City of Fredericksburg

Planning and Zoning Meeting Agenda
Wednesday, August 2, 2023 ~ 5:30 PM
Law Enforcement Center
1601 E. Main Street
Fredericksburg, Texas 78624

PLANNING AND ZONING COMMISSION **AGENDA MEMO**

Z-2311

SITE PLAN

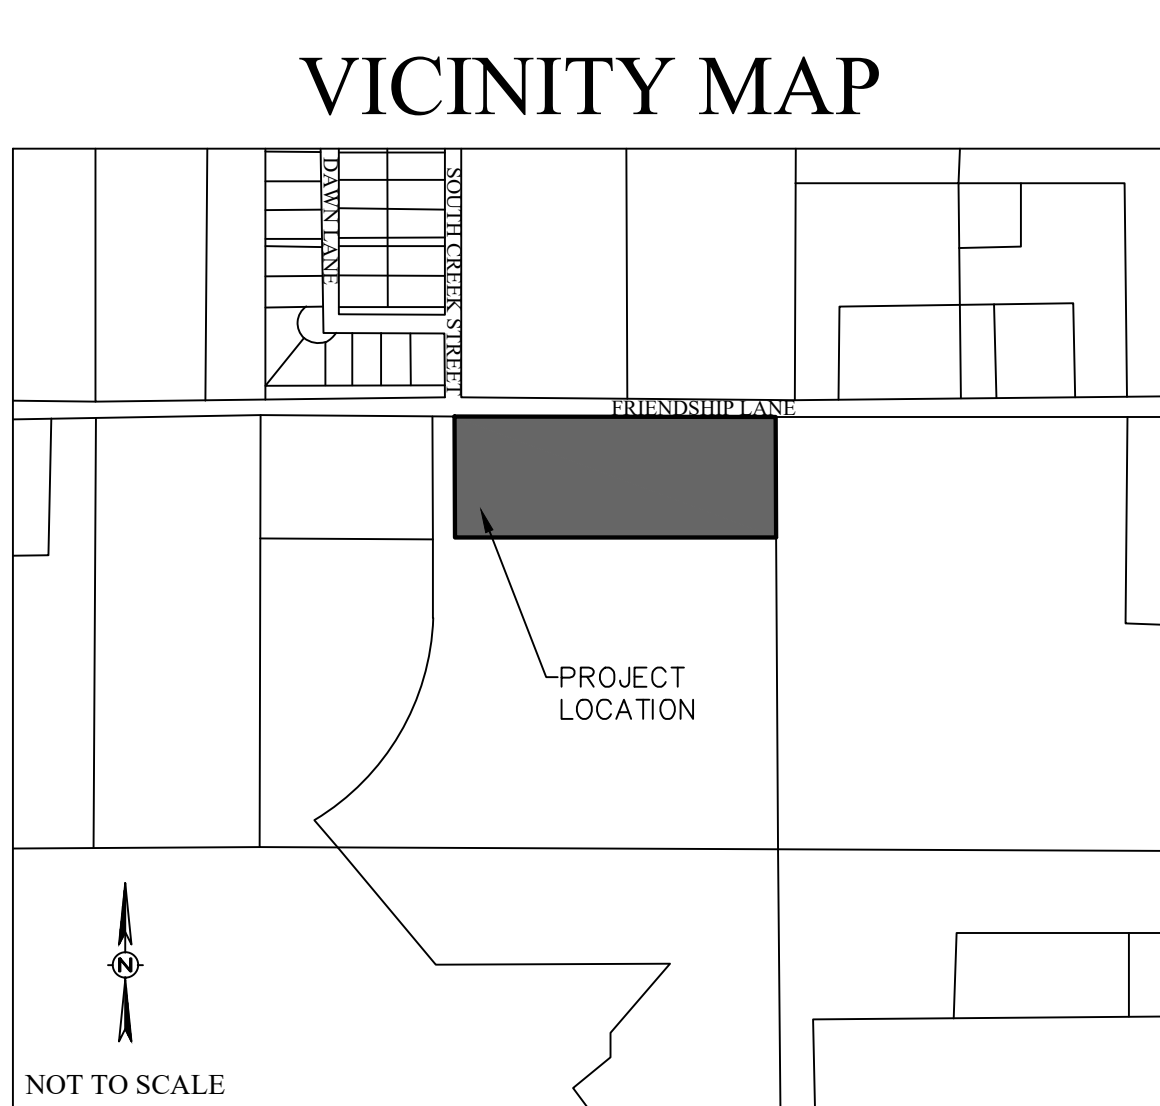
1. Conditional Use Permit and Entry Corridor Review requires Planning and Zoning Approval, scheduled for August 2, 2023.
Noted.
2. Provide location of solid waste container Sec. 3.110 – Site Plan Checklist.
Note 3 addresses solid waste.

3. Please determine density and update Zoning Summary. Sec. 3.110.
The Zoning Summary has been updated.
4. Provide modify the proposed addressing plan starting with unit 100 on the southwest side of the development and working counterclockwise around parcel. Follow the driving path. Sec 7.131
The unit numbers have been modified.

5. Condominium Plat is required once the Final Plat (P-2316) is approved.
Noted.
6. Please provide a CUP Narrative with specific responses to each of the review and evaluation criteria noted in Sec. 5.460. This will be used by the Planning and Zoning Commission and City Council to make their determination. Please explain that the requested use is Condominiums. If it is your desire to rent these units as Short-Term Rentals a Conditional Use Permit is required and the desired use needs to be identified now. Definitions are found in Sec. 2. 100.

7. Please provide a note regarding all exterior lighting shall be night sky compliant. Provide the requested Fixture Type Article XV – Outdoor Lighting – Site Plan Checklist.
Note 6 discusses the exterior lighting, and attached is a sample fixture specification, although no fixtures have been selected at this time.

8. Provide location of existing landscaping/trees Sec. 7.131-Sec. 7.920 – Site Plan Checklist.
There are no existing landscaping/trees located on this site.

9. Provide a Landscape and Screening Plan per Sec. 7.920 – Sec. 7.980. To include calculation of all required landscaping onsite. Site Plan Checklist.
As a condition of the Conditional Use Permit we would like to use Note 5 on the Conditional Use Permit Plan as our response to the landscape and screening requirements for this submittal. At a later date we will submit a landscape and screening plan that meets the City's Requirements including calculations of all required landscaping onsite.

10. This project will require review and approval of civil construction plans. The development will be required to comply with City ordinances for access, utilities and stormwater controls.
Noted this project will submit civil construction plans with the site plans submittal and will comply with the required City ordinances.

11. This site is subject to the Annexation Agreement for the Friendship Oaks development. Any impacts to this site for improvements that are required for the Friendship Oaks subdivision will be required from this site upon development and be shown in the approved plans.

Noted, a sidewalk has been added along South Creek Street and Note 7 has been added to the plan.

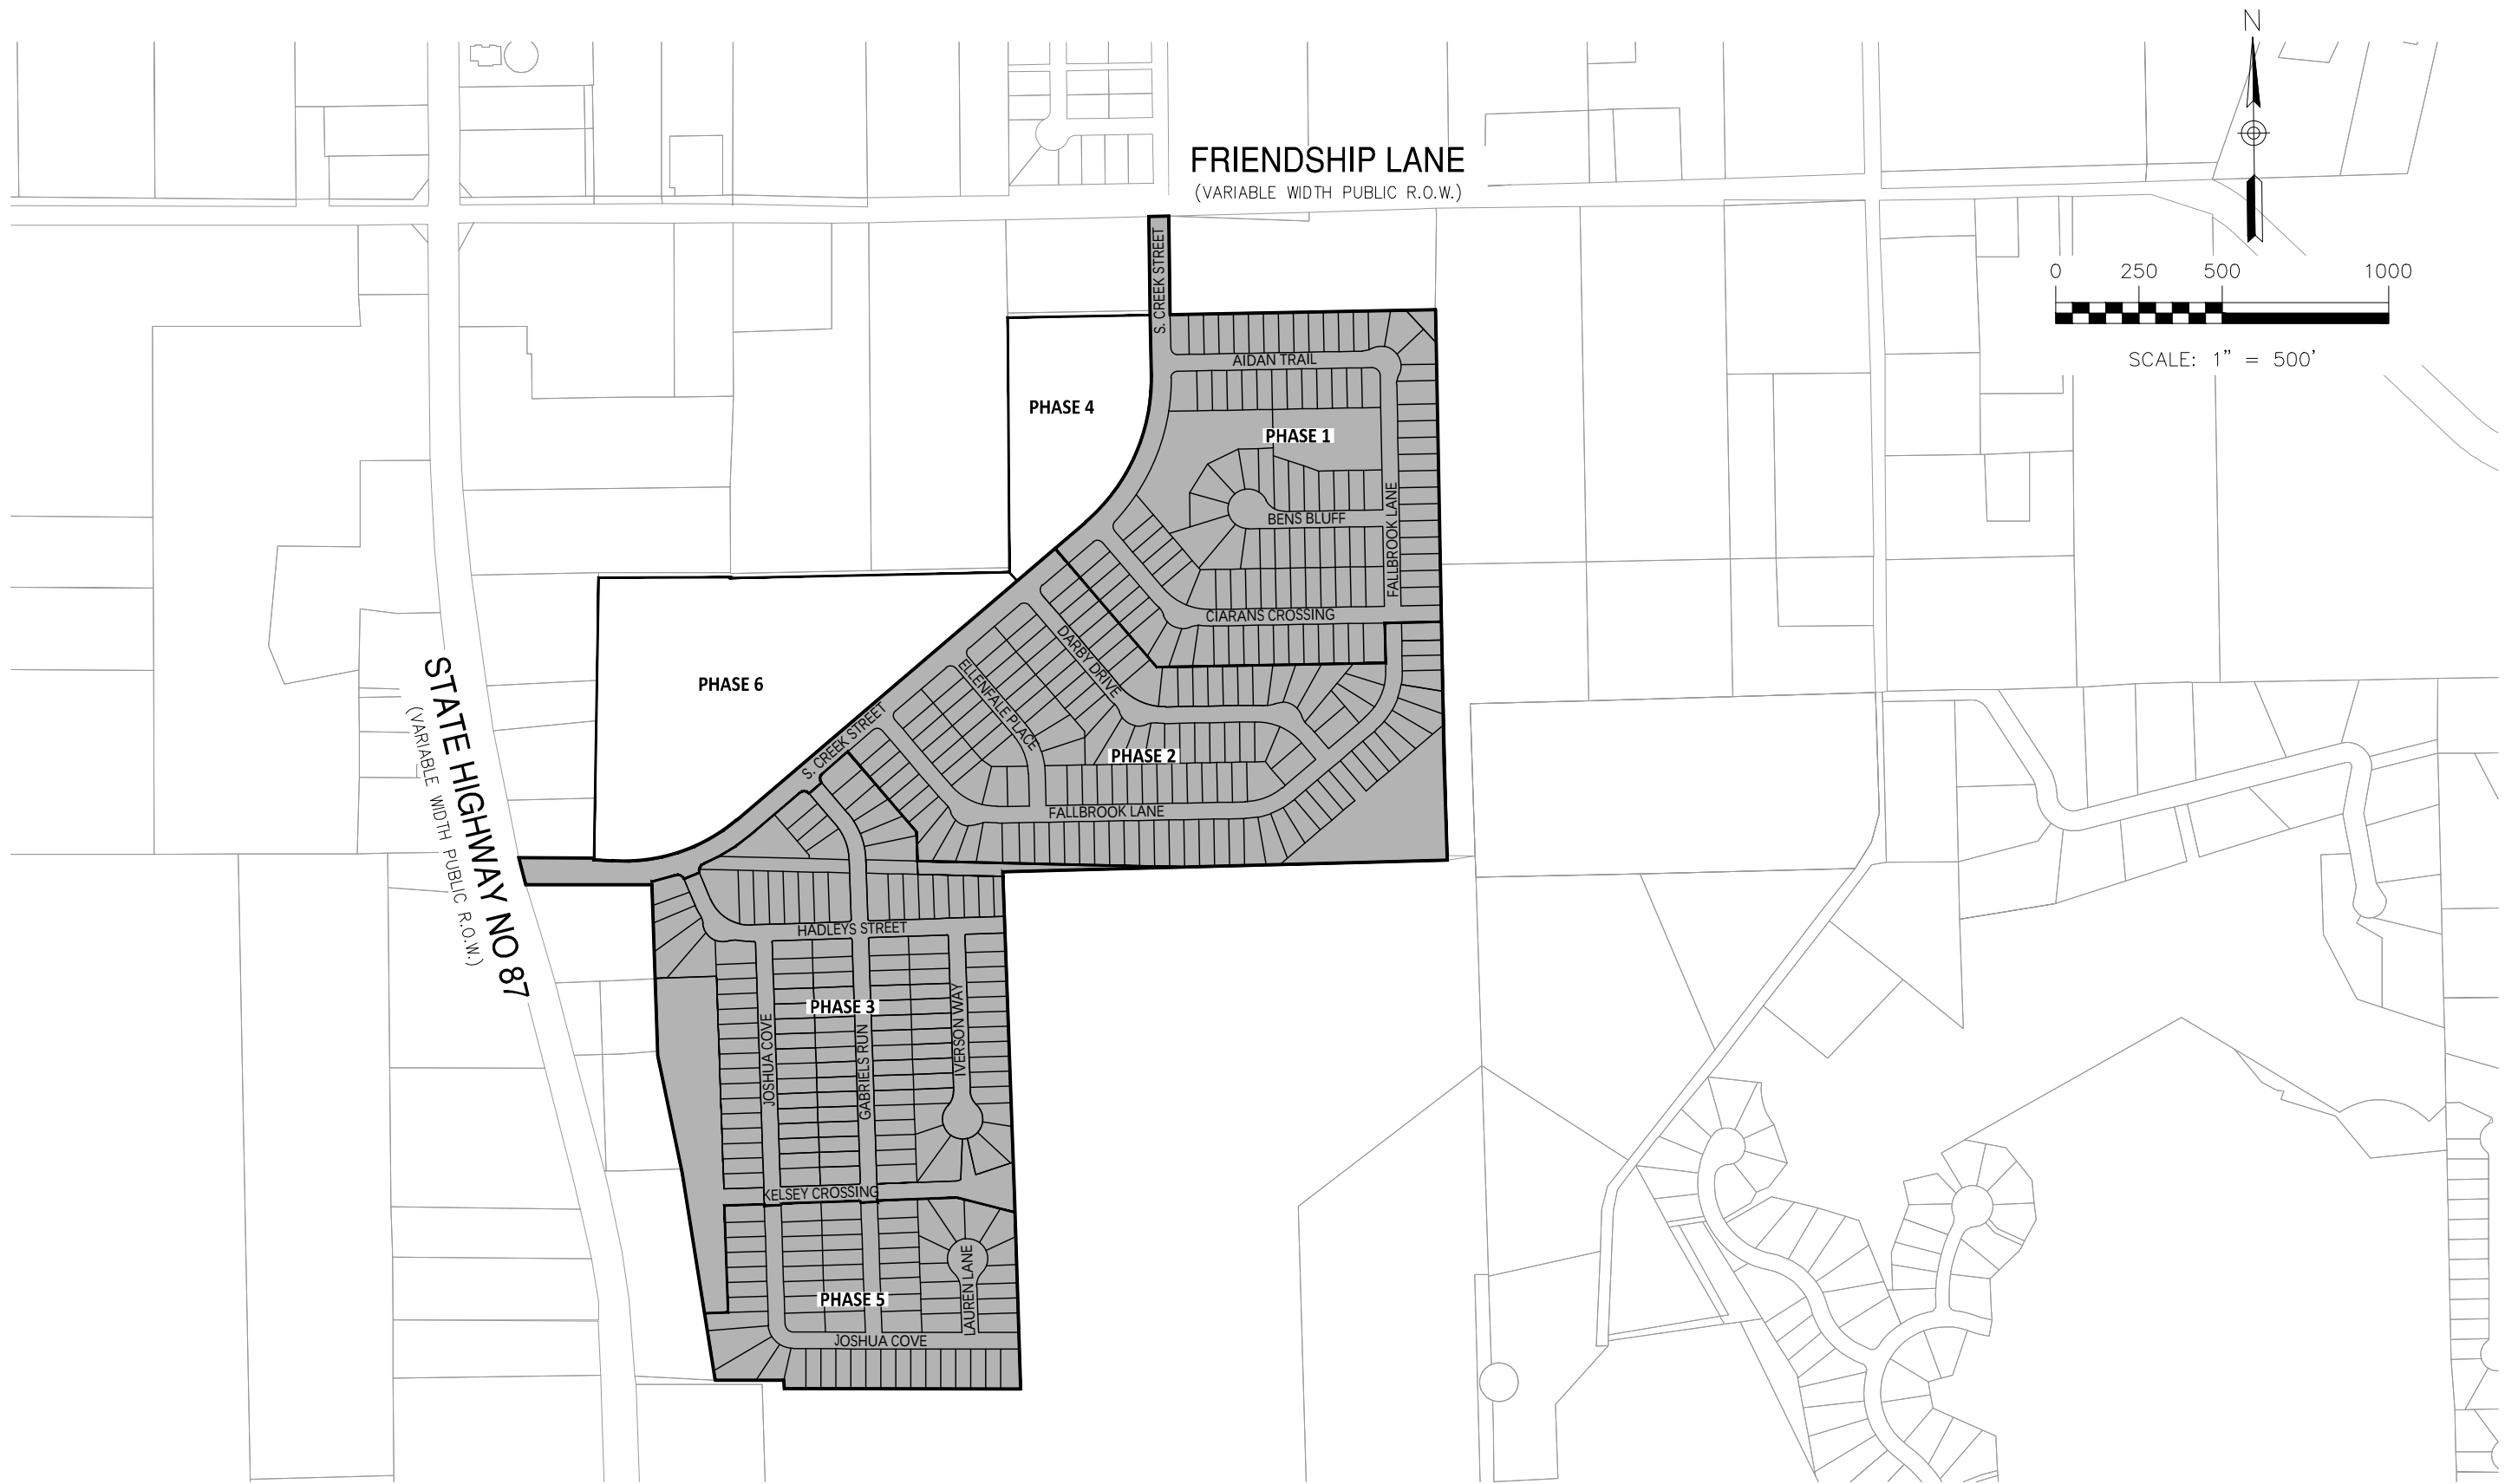
traffice with all the new appartments, new
school, and retirement housing. The main
protest would be the increased use of water,
which is now restricted.

Beatrice Y. Price
Signature

Staff Conditions:

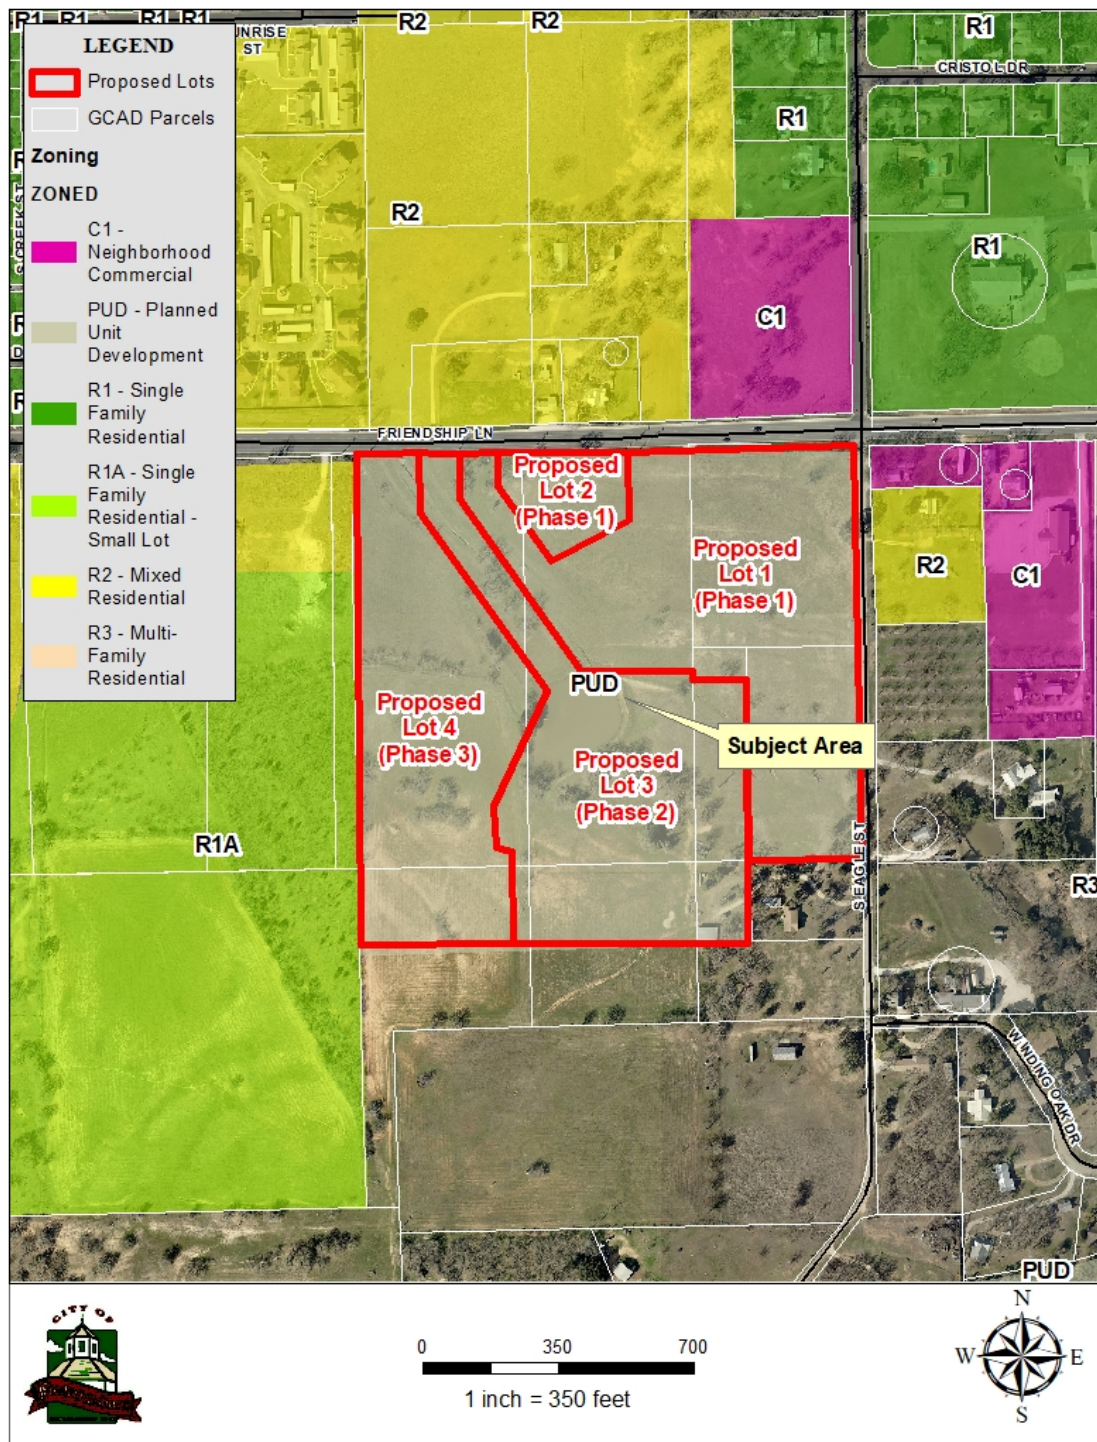
1. Correct wording in Note 1 to read: "No landscaping or other modifications..."
2. Show right of way ties for Friendship Lane and S. Eagle Street.
3. Provide shared access easement based on latest agreement with adjacent property to the west.
4. Add all notes from the preliminary plat that were not included on the final plat.
5. Provide escrow for required public improvements, to include an engineer's cost summary.
 - a. Parkland Dedication fees shall be paid as part of the building permit process for each phase of the development.
6. Remove the phases from the lot labels.
7. Provide a plat note establishing an HOA or other entity that will be responsible for ownership and maintenance of all private infrastructure within the development.
8. Show access easements over all roadways crossing property lines.
